SYNOPSIS OF QUESTIONS AND ANSWERS (NO. 3) FOR SALE OF SITE FOR COMMERCIAL DEVELOPMENT AT ORCHARD ROAD / SOMERSET ROAD (SOMERSET CENTRAL)

(Total of 3 Q&A – dated 4 July 2006)

**BASEMENT 2 PLAN
(MRT CONCOURSE LEVEL)**

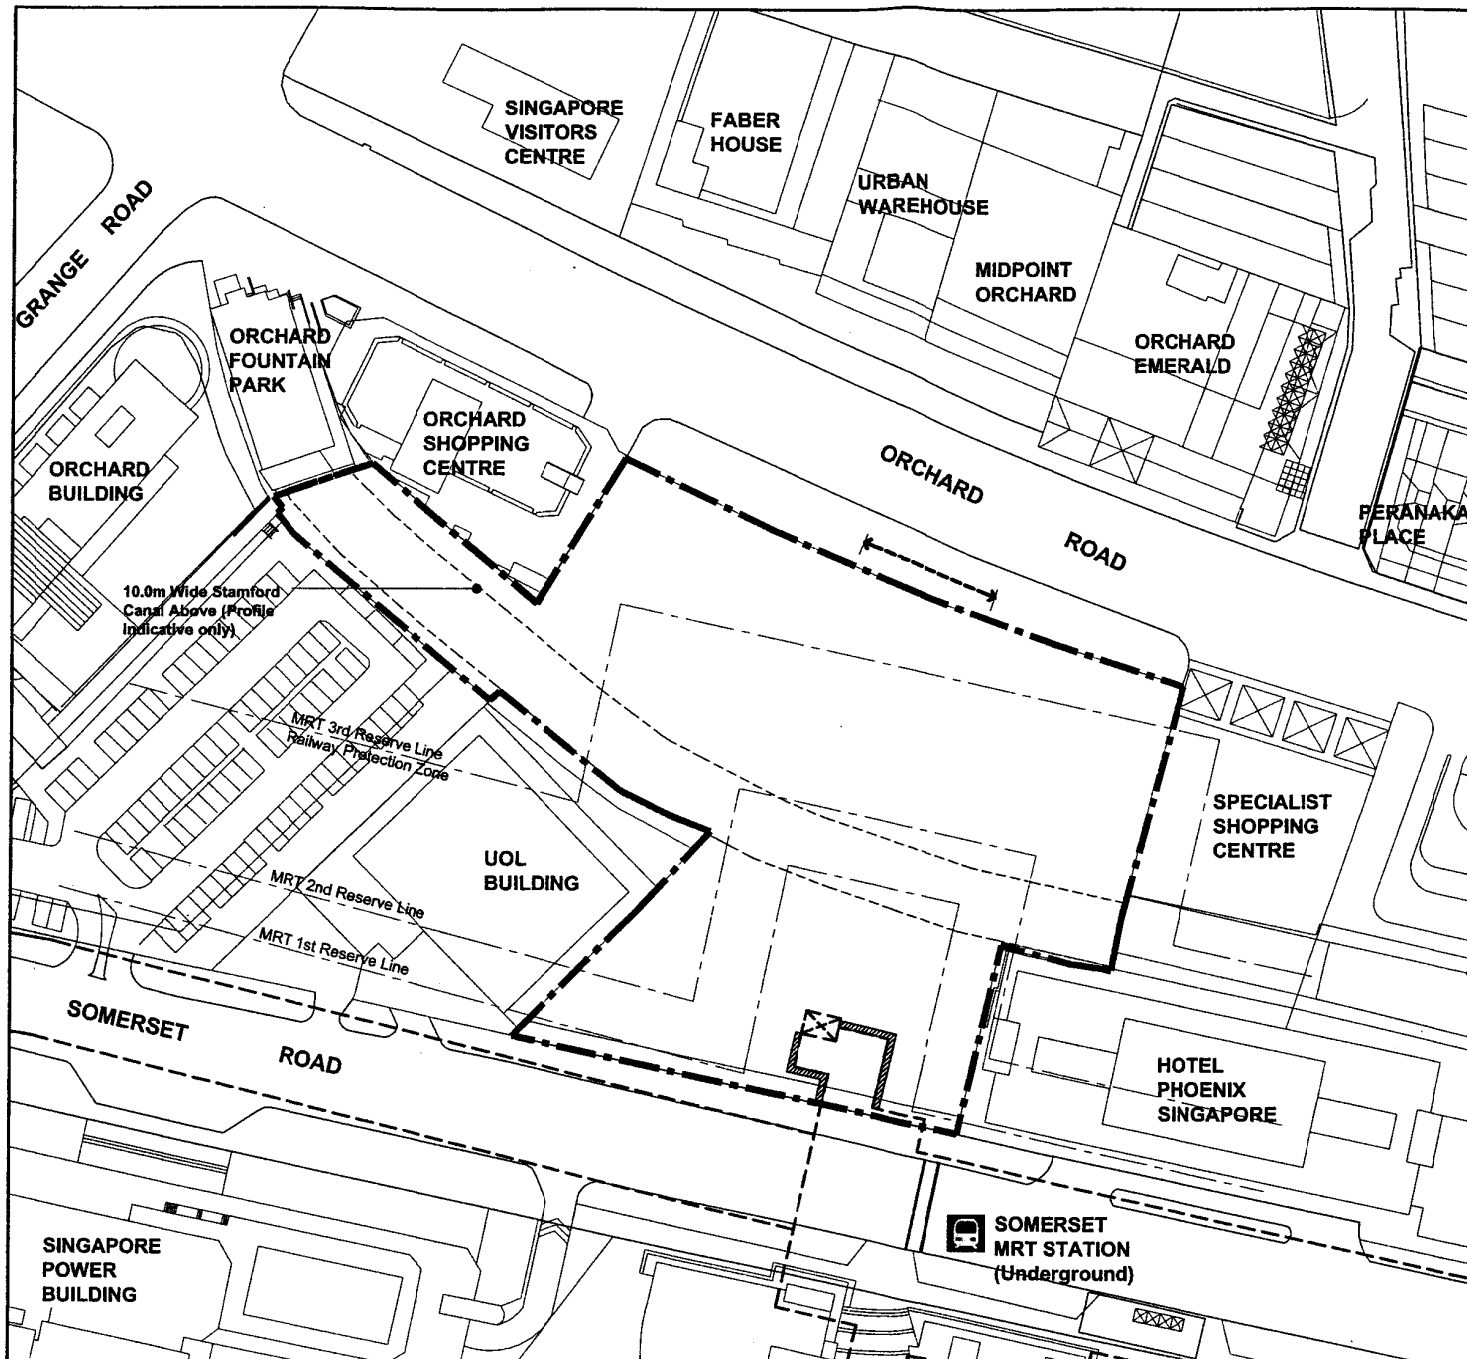
Q2 Clause 4.16.3 of the technical conditions of tender (TCOT) states that the developer is to provide a knock-out panel at Basement 2 of the development if a development with 2 basements is proposed for the site. We understand that the knock-out panel will be connected to a future underground pedestrian walkway underneath Orchard Rd to provide a direct linkage to a development opposite the Somerset Central site. May we enquire which development along Orchard Rd will the underground pedestrian walkway be connected to? A schematic layout plan showing the underground pedestrian network system will be very helpful in this case.

A2 As part of the urban design plans for Orchard Road, underground pedestrian links have been safeguarded around MRT stations to allow pedestrians to walk in sheltered comfort between developments and to and from MRT stations. As part of the underground pedestrian network planned around Somerset MRT station, the successful tenderer of the Somerset Central site would have to provide a knock-out panel within the development to facilitate the development of a future pedestrian link to Orchard Midpoint (see location plan at Annex B). For more details on the underground pedestrian network planned along Orchard Road and around Somerset MRT station (Annex C), please refer to our circular "Urban Design (UD) Plans and Guidelines for the Orchard Planning Area" dated 4 Feb 02 which is available on URA's website at www.ura.gov.sg.
